ADDENDUM# 6

UK Level B Support Services BP-2
ADDENDUM No. 6
CCK-2655-23
10/11/2022

BP-2_ADDENDUM NO. 6

Subject: Renovate/Upgrade UK Healthcare Facilities
Pavilion A Level B Support Services Renovation
UK # 2239.77

**LEVEL B DEMOLITION
PLAN - AREA A PHASE 2**

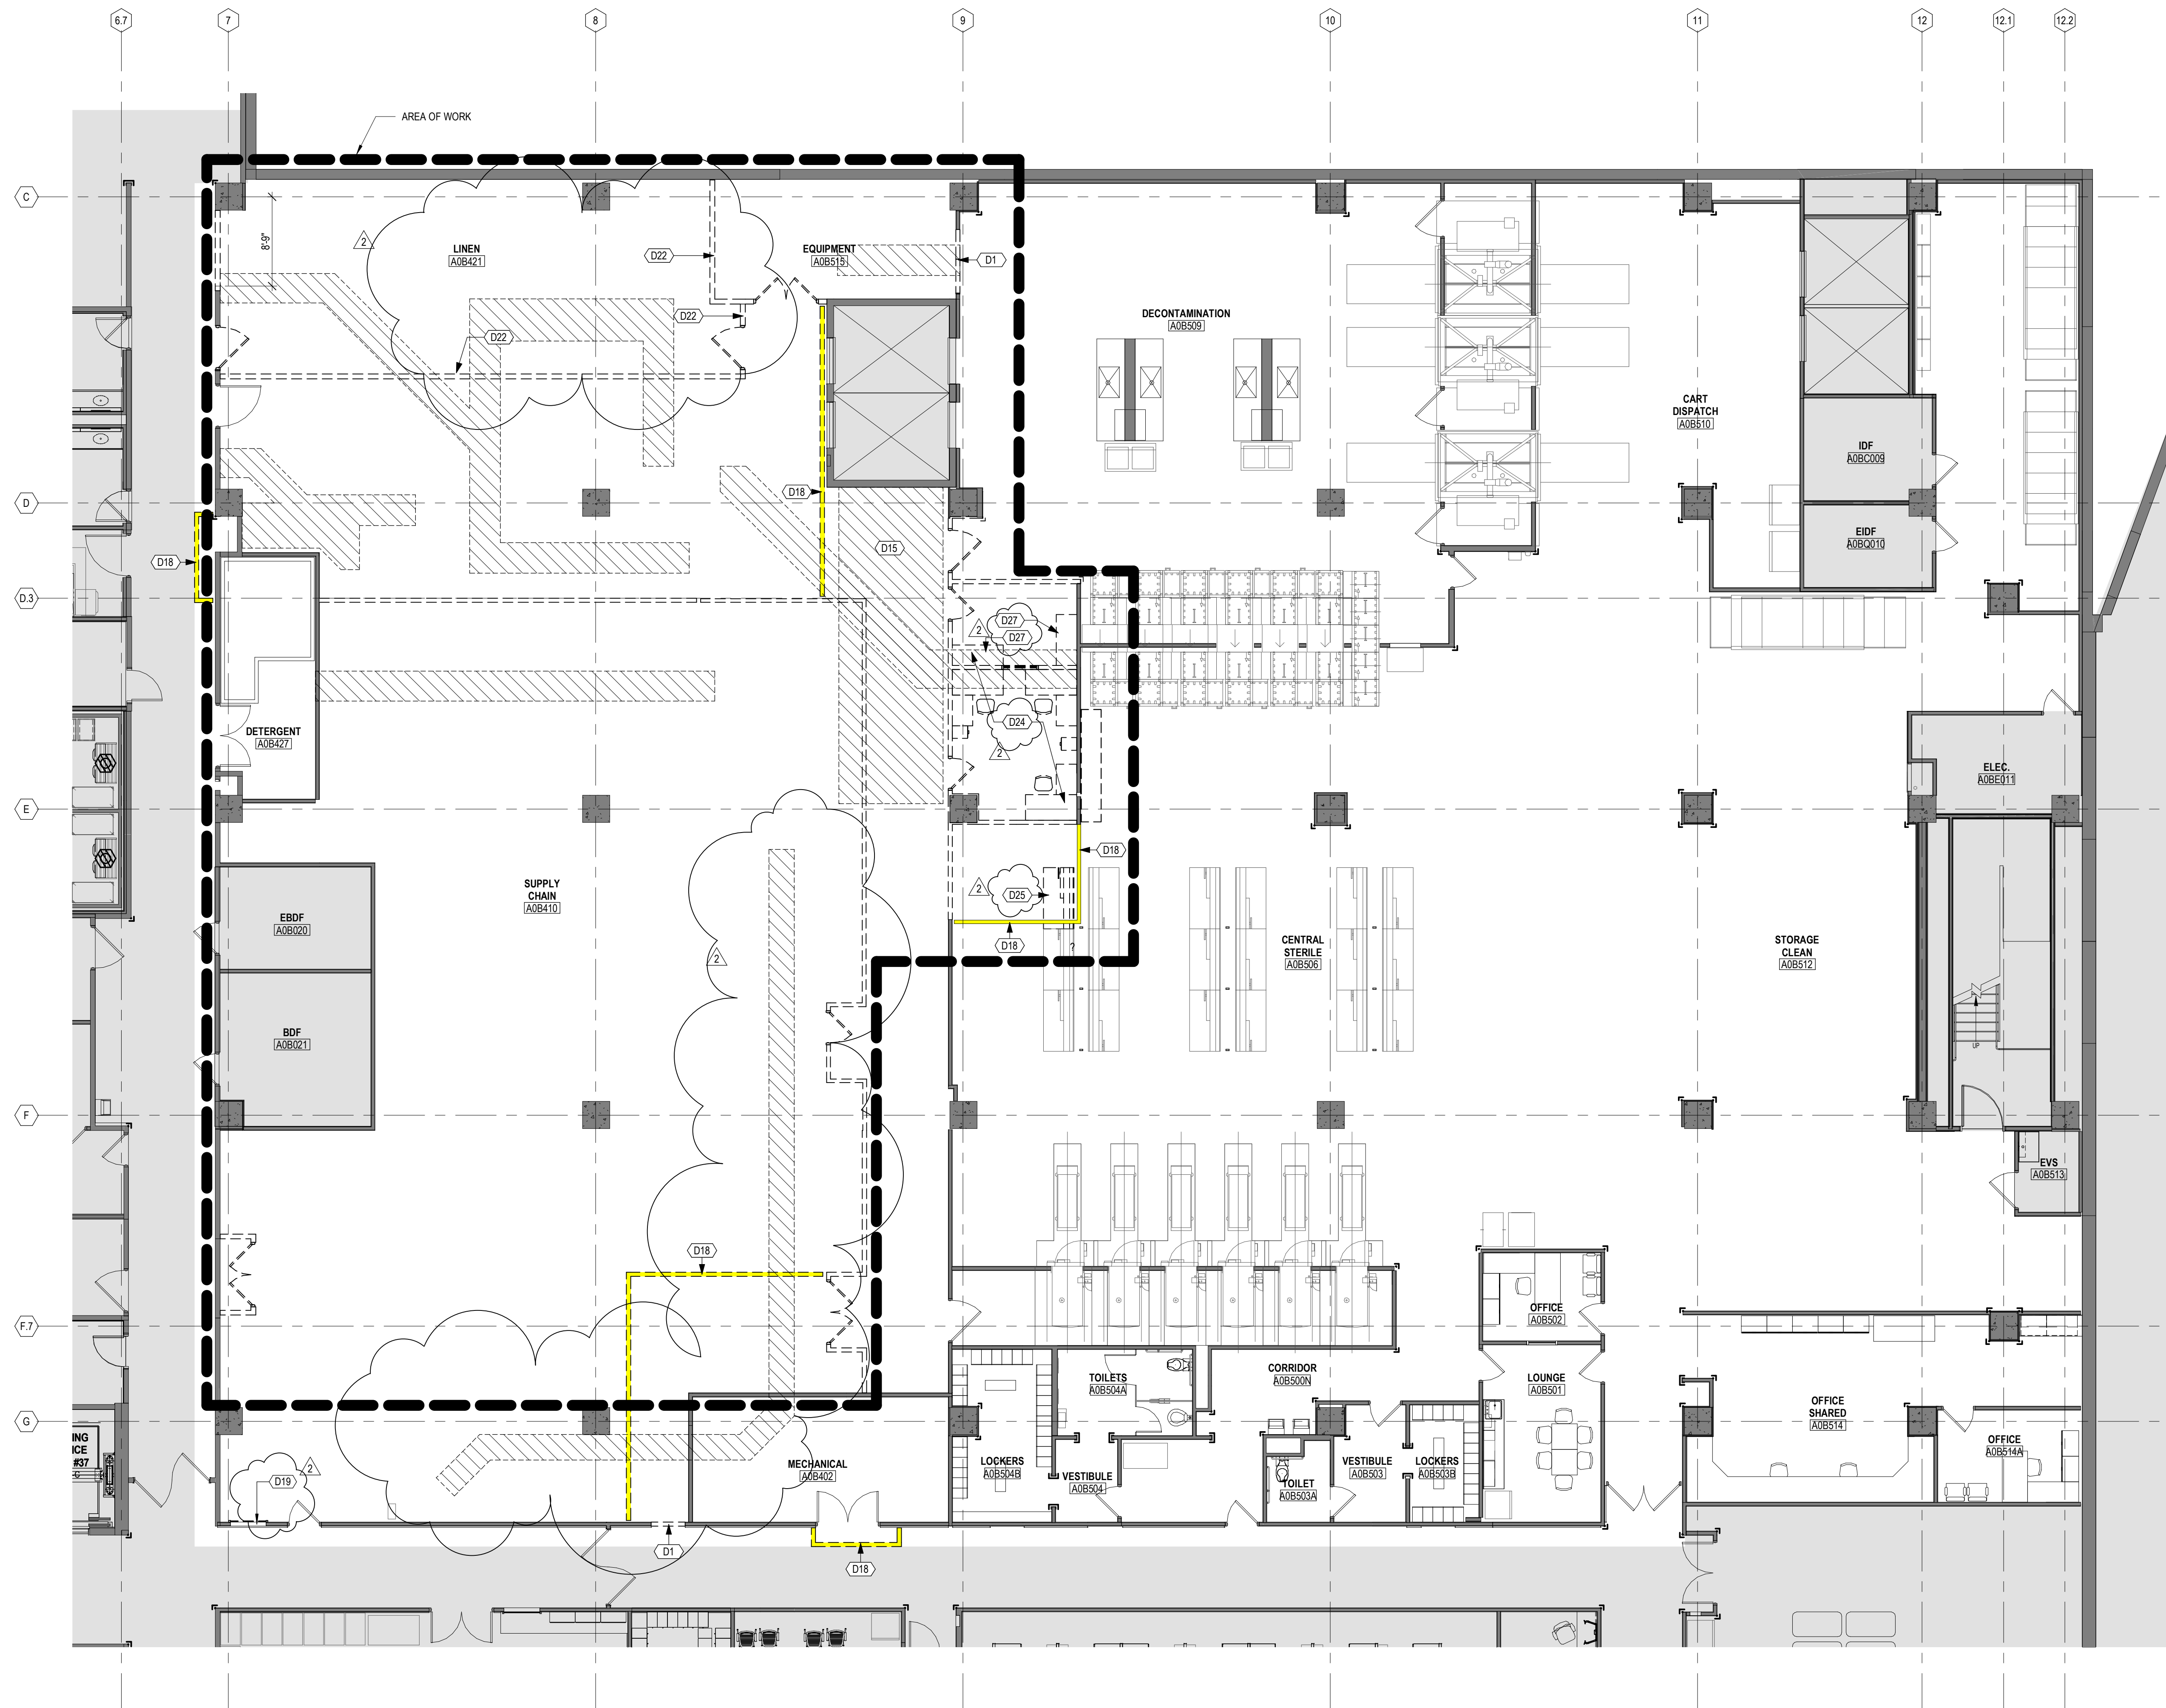
- 2.1 Sheet EQ20BA – 01.31.11 Record Drawing**
- 2.2 Sheet D10B-A.1 LEVEL B DEMOLITION PLAN – AREA A PHASE 1**
 - A. See clouded areas
- 2.3 Sheet D10B-A.2 LEVEL B DEMOLITION PLAN – AREA A PHASE 2**

**LEVEL B DEMOLITION
PLAN - AREA A PHASE 3**

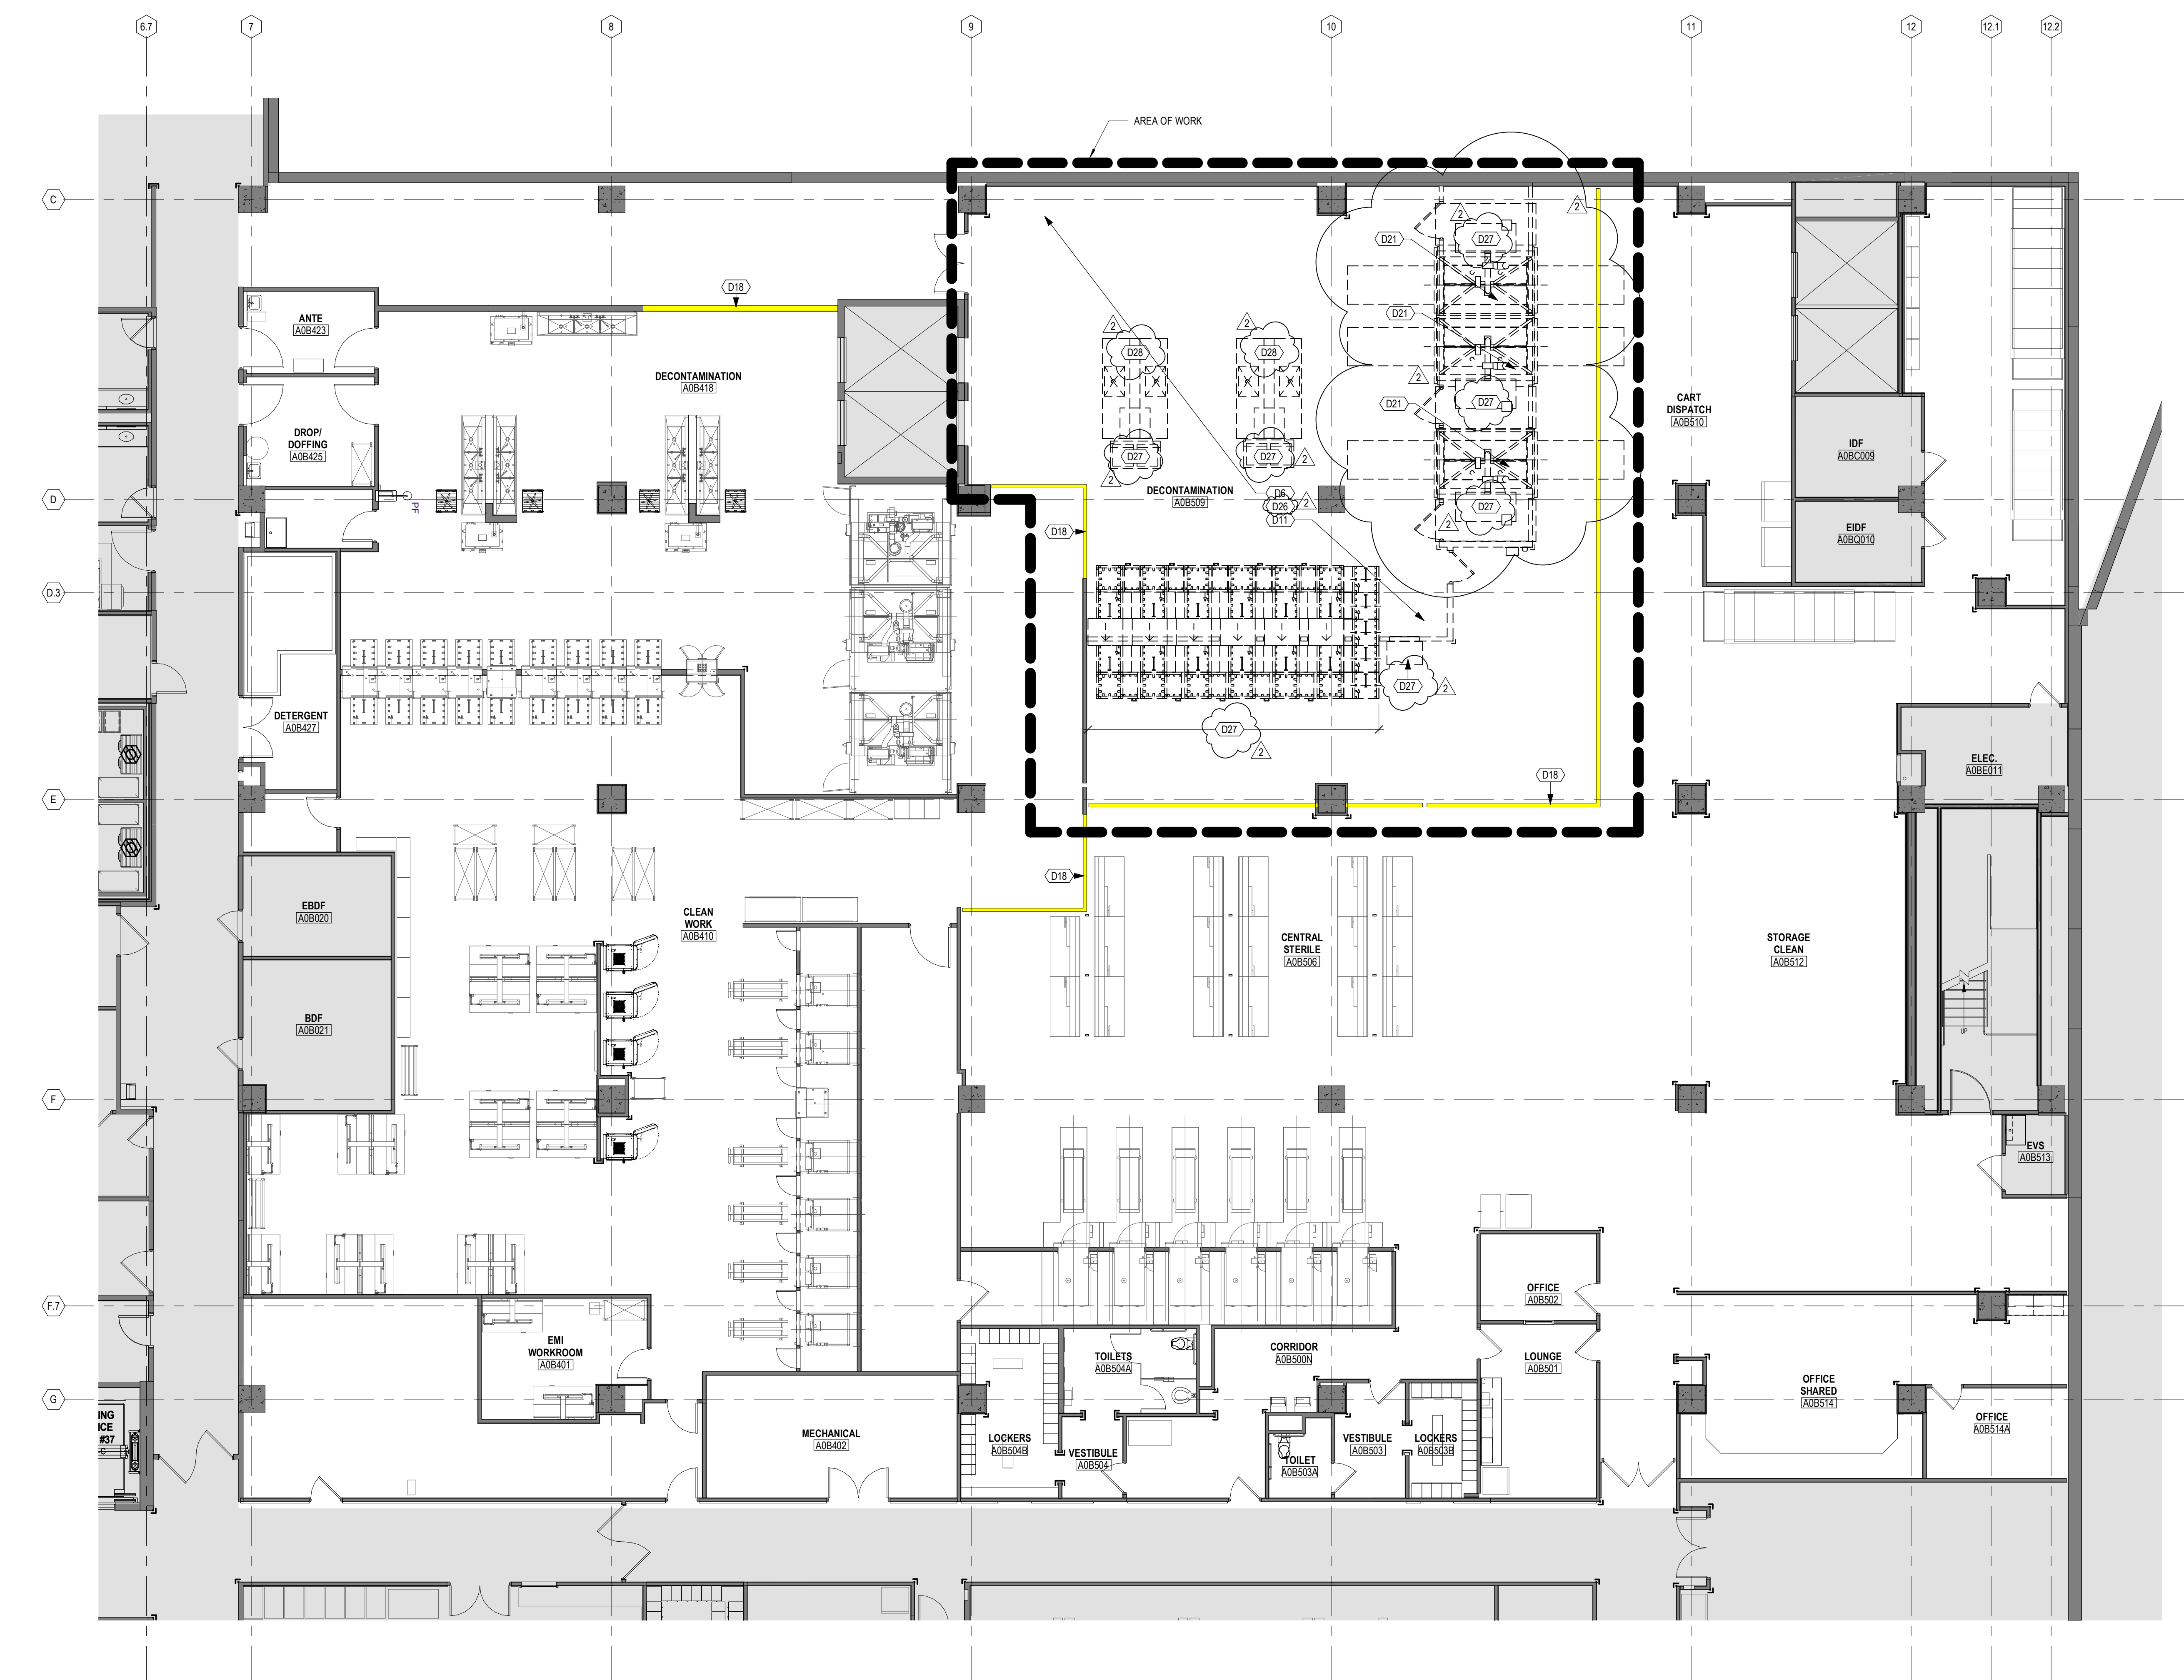
- A. See clouded areas
- 2.4 Sheet D10B-A.3 LEVEL B DEMOLITION PLAN – AREA A PHASE 2**
 - A. See clouded areas
- 2.5 Sheet D10B-A.4 LEVEL B DEMOLITION PLAN – AREA A PHASE 2**

10.	D10B-A.1 shows an existing overhead counter door (Room A0B400) which is shown removed in D10B-A.3. Is this door to be removed & opening filled? Which TC is responsible for demo & infill?	<p>The existing overhead counter door, accessories, and countertop, are to be removed by TC-209. The intent is to match the existing adjacent conditions, which is a gyp board assembly. The infill of this opening is by TC-210.</p> <p>D10B-A.1 room A0B400 does not denote an overhead door to be demolished. D10B-A.2 does show the overhead door at the bottom left dashed and A10B-A.2 shows the infill to be a 1 hour smoke barrier per the Partition and Wall Graphic Key. Infill with wall type 3 SB.</p> <p>See drawings in Addendum 6</p>

**LEVEL B DEMOLITION
PLAN - AREA A PHASE 5**

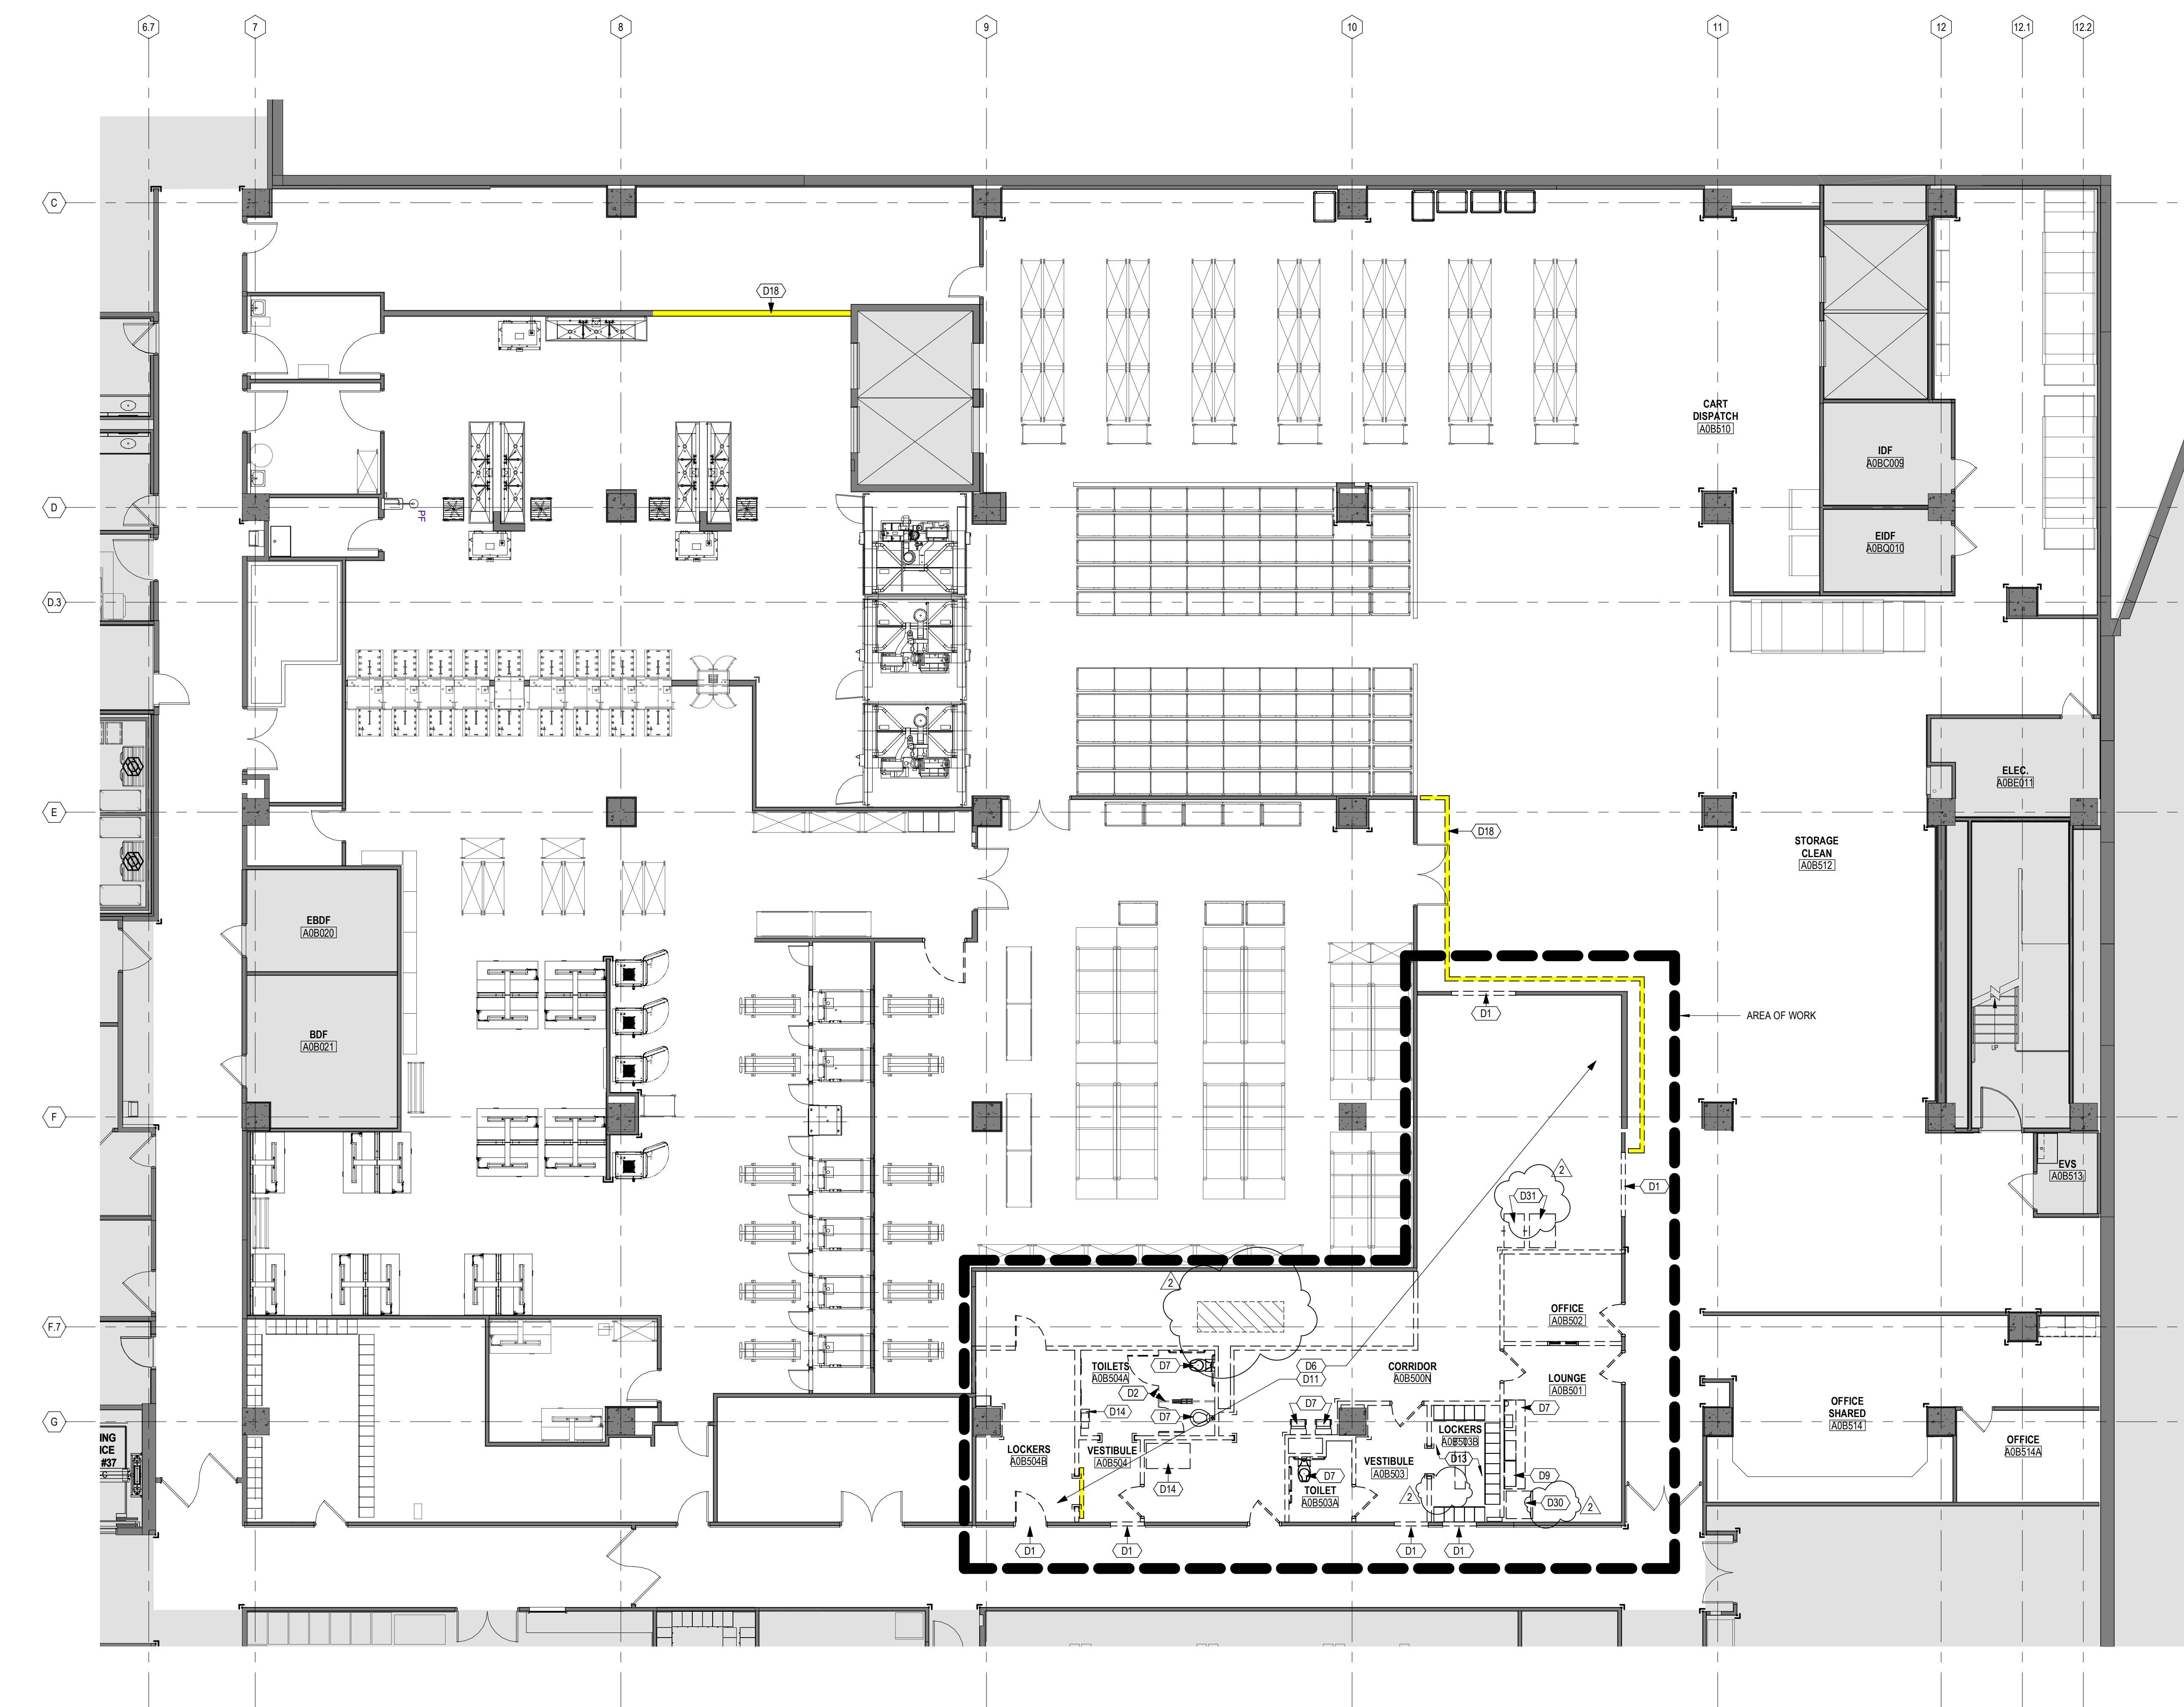
- A. See clouded areas
- 2.6 Sheet D10B-A.5 - LEVEL B DEMOLITION PLAN – AREA A PHASE 5**
 - A. See clouded areas
- 2.7 Sheet D10B-A.6 LEVEL B DEMOLITION PLAN – AREA A PHASE 2**
